City of Gem Lake

City Council Meeting

November 17, 2026
7:00 p.m.
Heritage Hall
REVISED

B. 3651 Highway 61, 1491 County Road E East, 1485 County Road E East, and 0 County Road E East - Planning Case Z2026-006; Zoning Text Amendment to Amend Language in the Building Use Type 15a for Automotive Dealerships; Planning Case Z2026-004; Minor Subdivision; Planning Case Z2026-003; Zoning Compliance Permit.
    a. Ordinance 2026-03; Zoning Text Amendment
    b. Resolution No. 2026-29; Resolution for a Minor Subdivision
    c. Resolution No. 2026-30; Resolution for a Zoning Compliance Permit

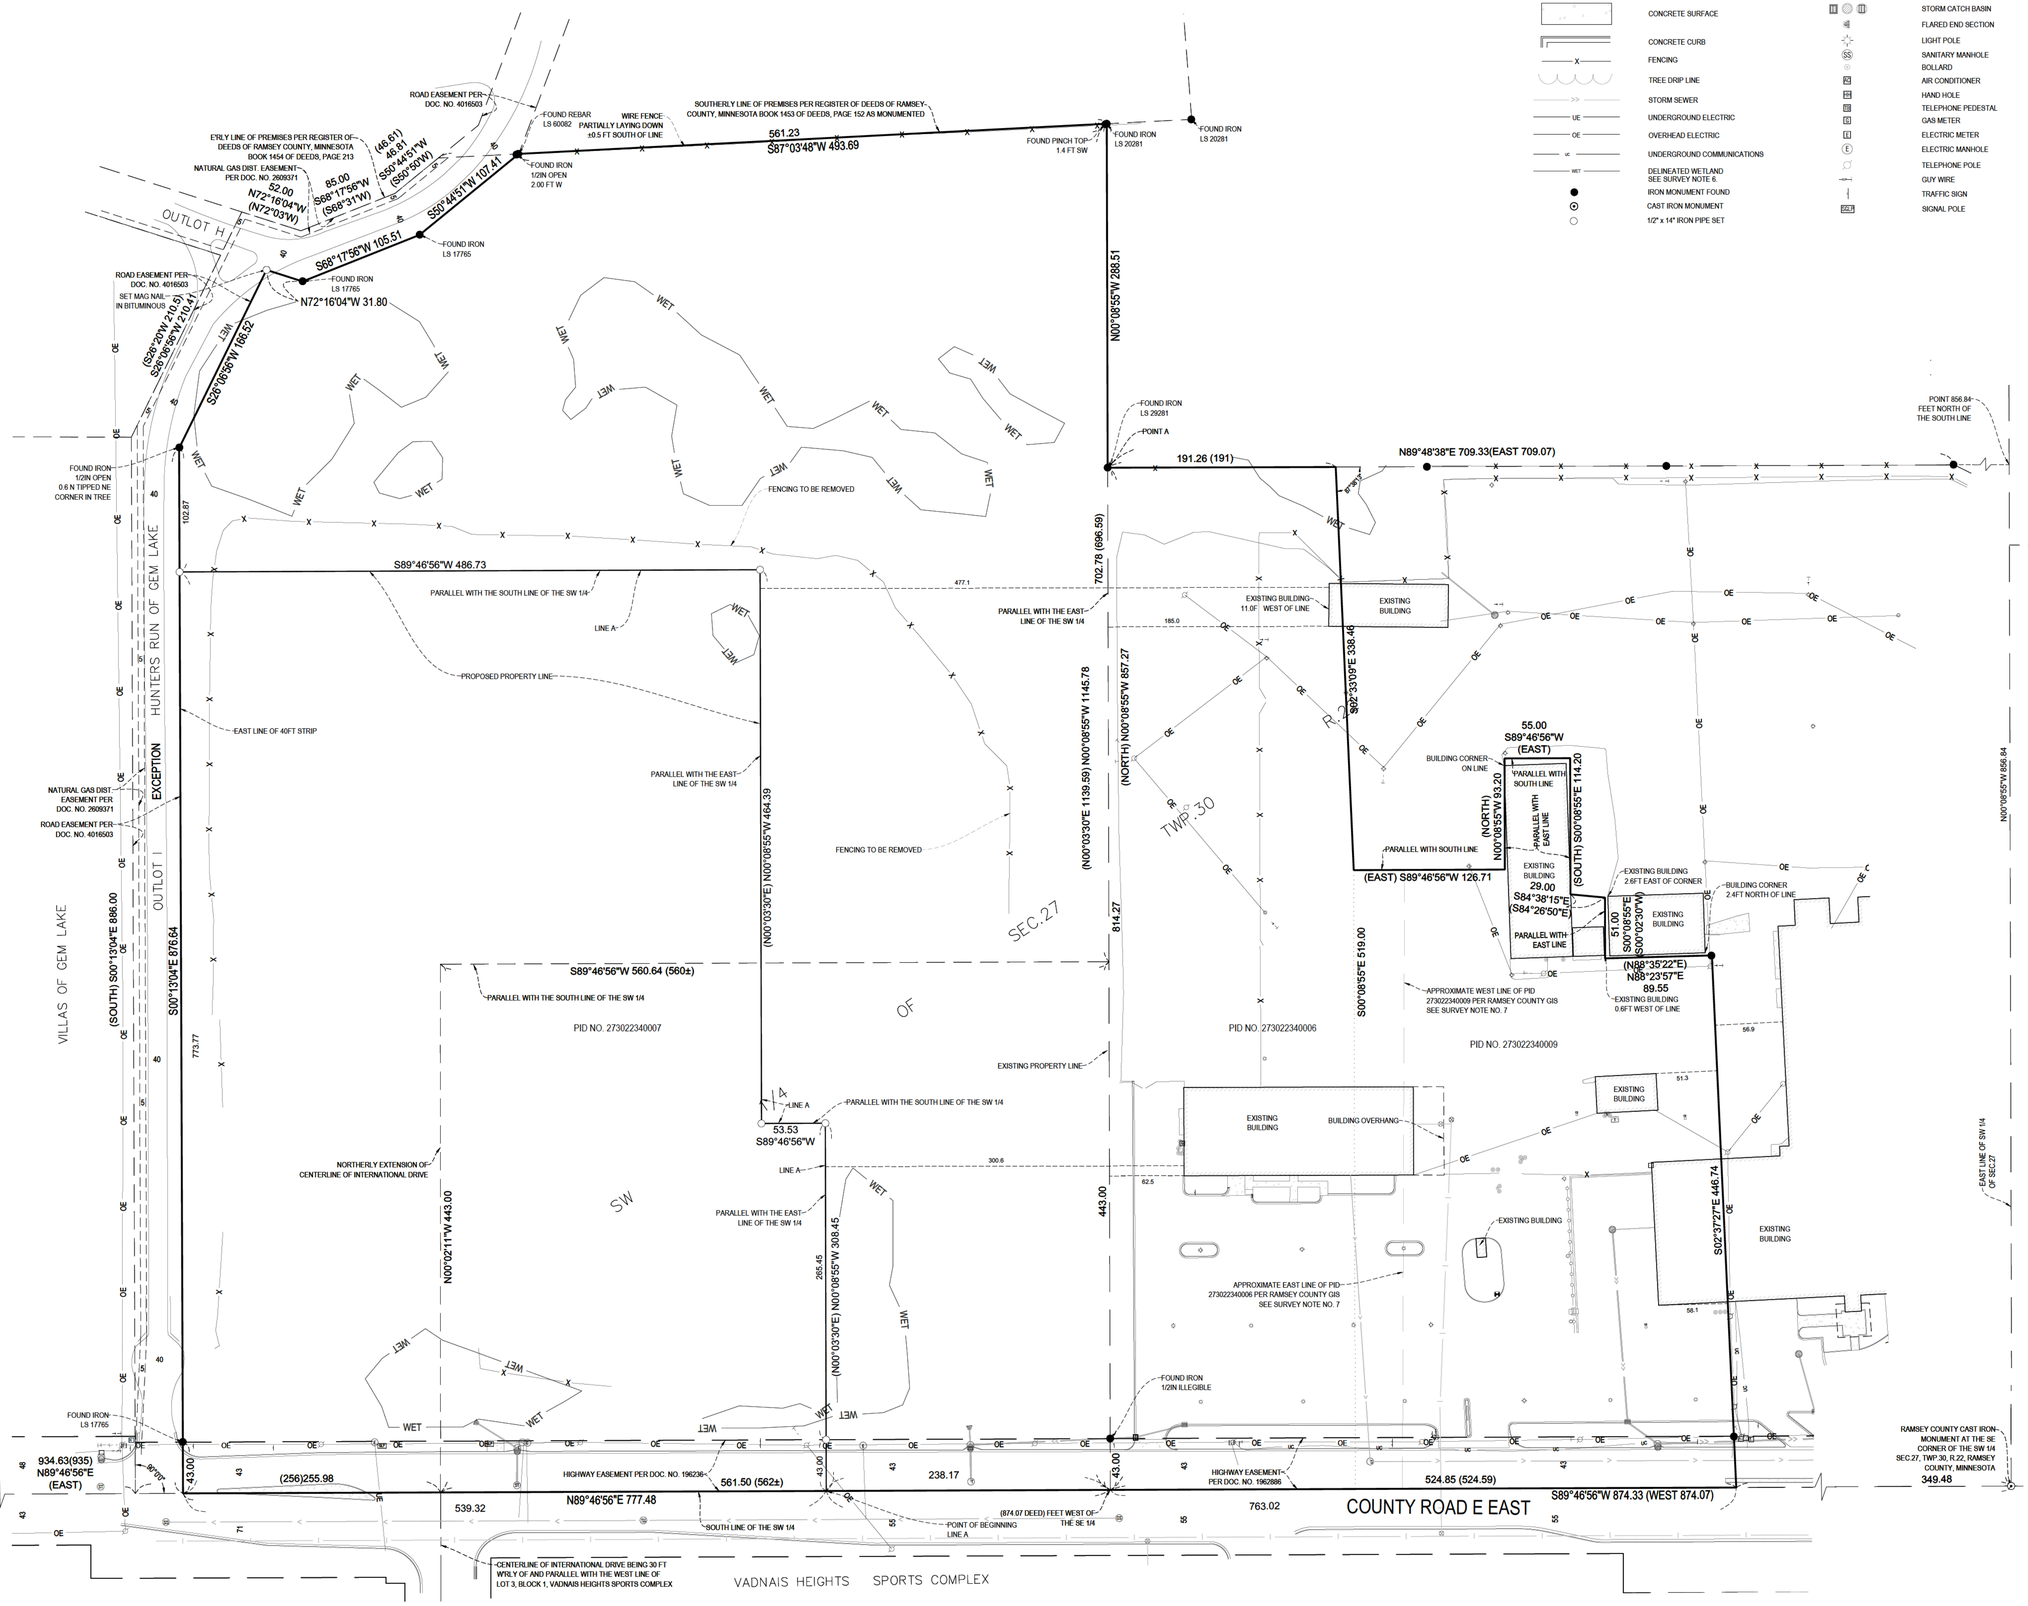
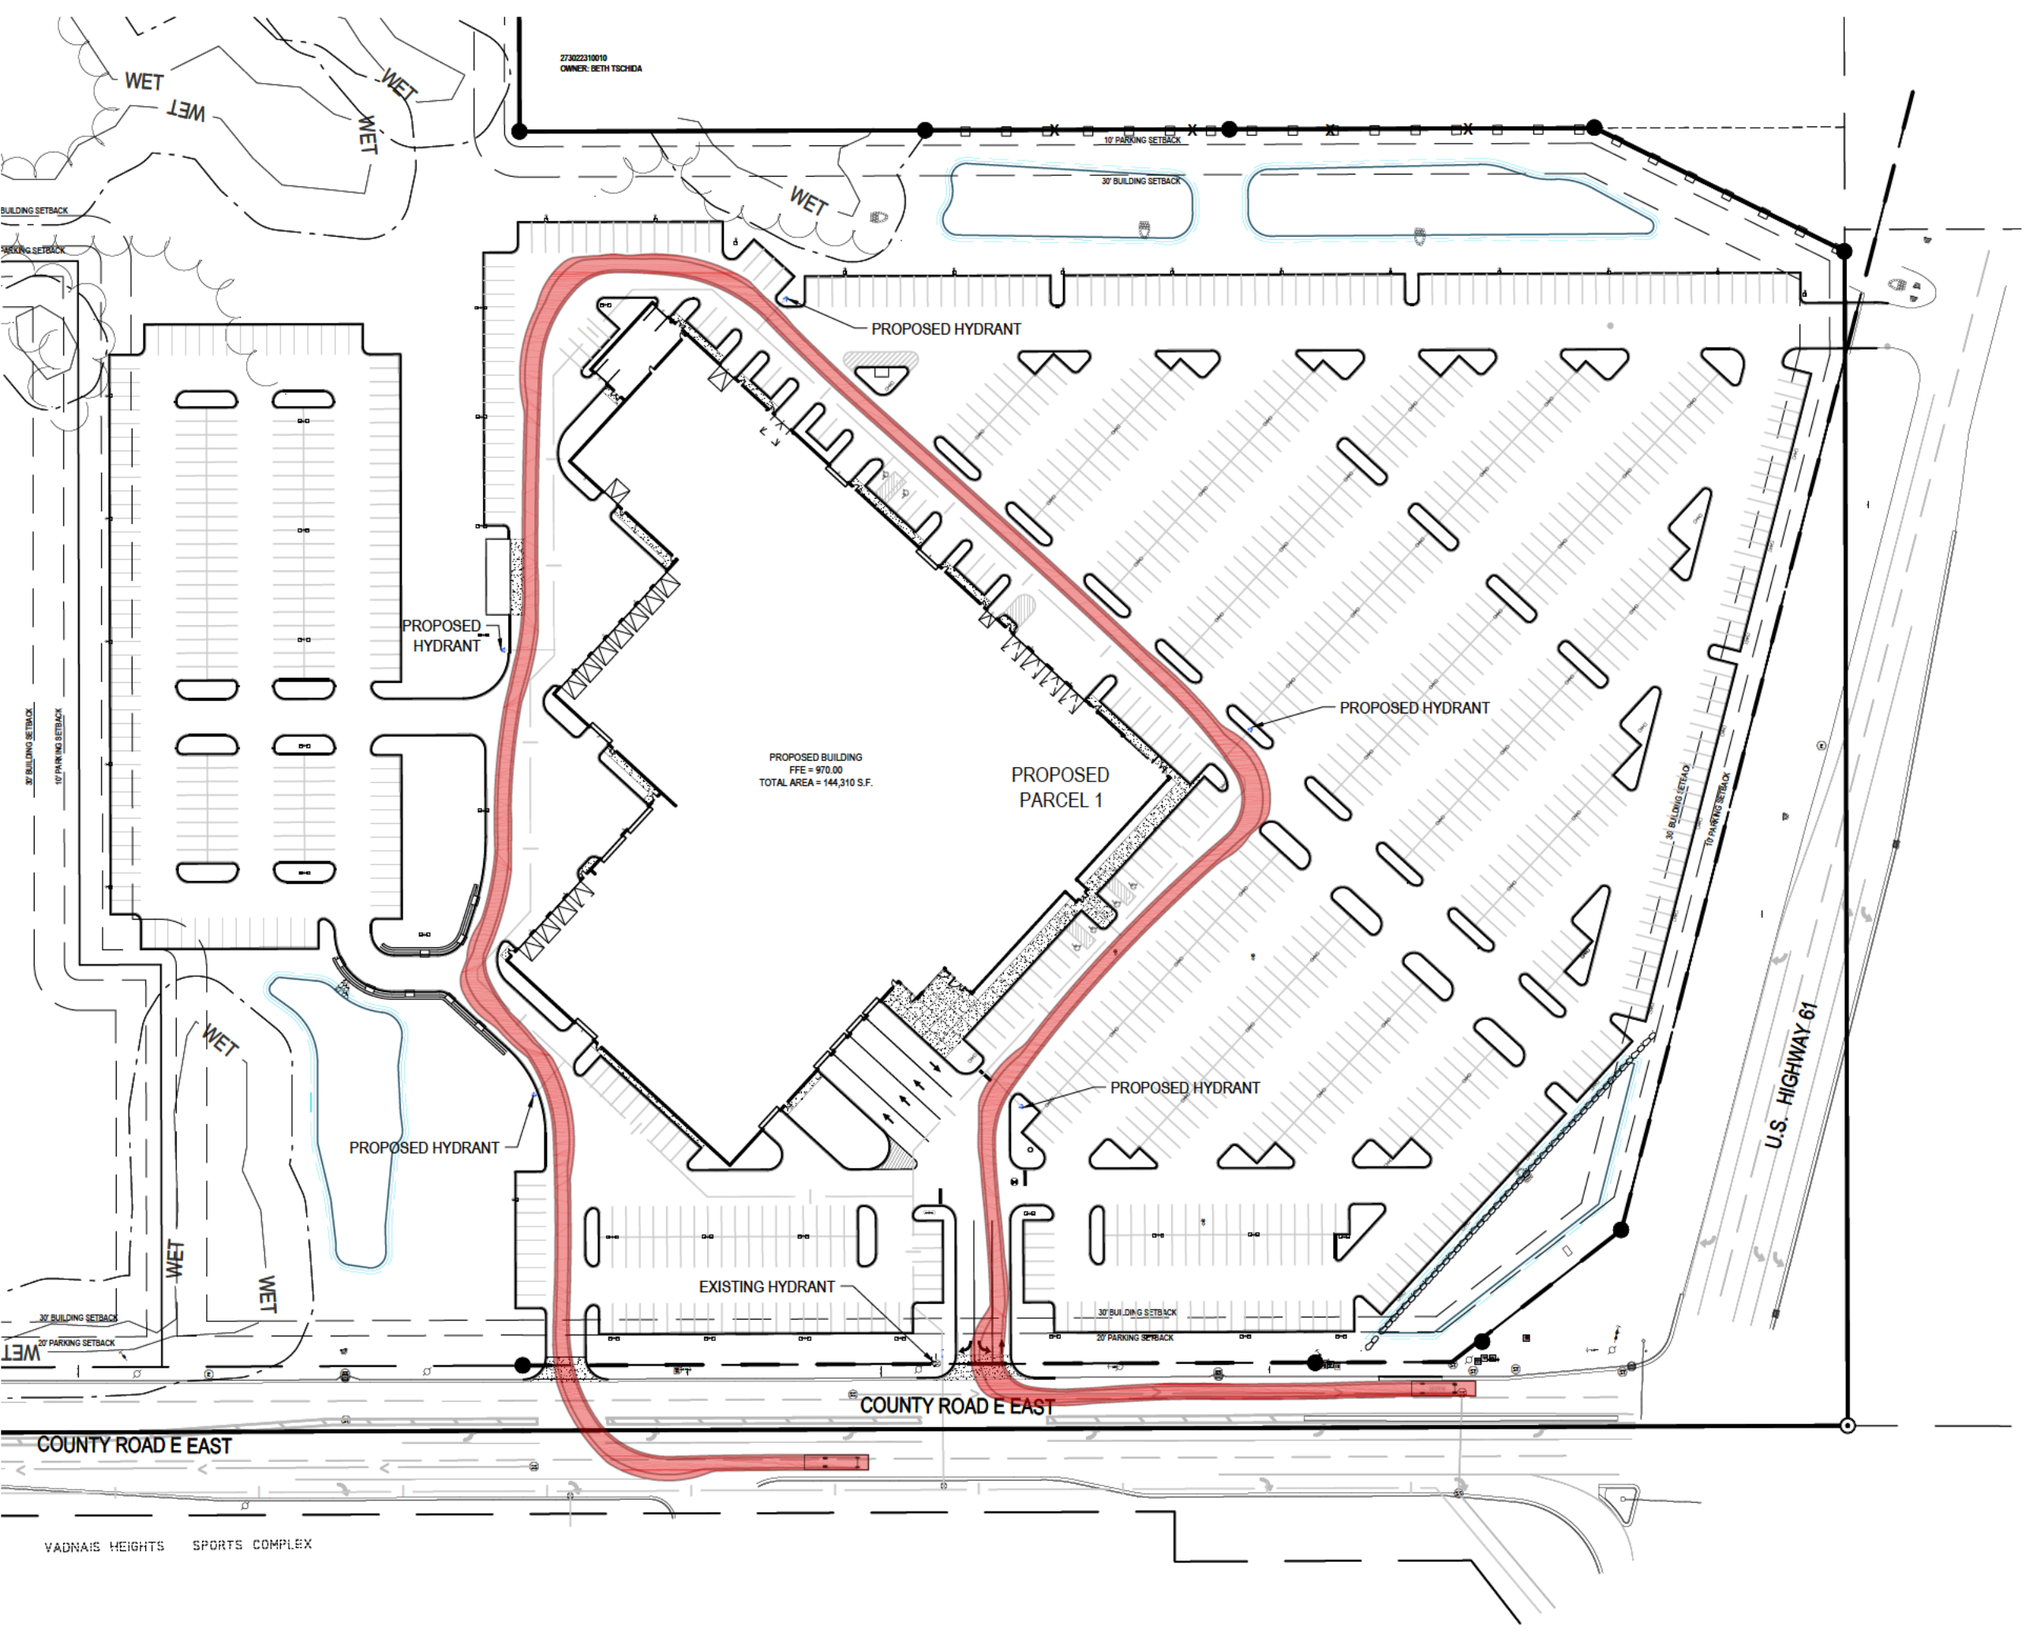
ii. Ramsey County has the following comments to be included as conditions of approval. Revise proposed plan details to show valley gutters reinstalled per the appropriate County detail. At the easterly entrance that is being removed, remove and replace the existing valley gutter, with curb and gutter to match the adjacent curb and gutter on CR E. Permits are needed for closure of existing accesses, new commercial accesses, stormwater connections, once approved, sanitary connection, and City water connection. Sheet C7.2, detail 10, revise to show the contraction joints perpendicular to the mainline curb and gutter.
        iii. The City of Vadnais Heights requires plumbing permits and inspections for the proposed public water connection with separate meters required for domestic, irrigation, fire protection and car wash uses for billing purposes. Ramsey County may require right-of-way permits, and copies must be submitted with the plumbing permit applications. Please

7) Ramsey County has the following comments to be included as conditions of approval. Revise proposed plan details to show valley gutters reinstalled per the appropriate County detail. At the easterly entrance that is being removed, remove and replace the existing valley gutter, with curb and gutter to match the adjacent curb and gutter on CR E. Permits are needed for closure of existing accesses, new commercial accesses, stormwater connections, once approved, sanitary connection, and City water connection. Maintenance Engineer stated that the contraction joints shown on C7.2, Detail 10 shall be perpendicular to the mainline curb and gutter.
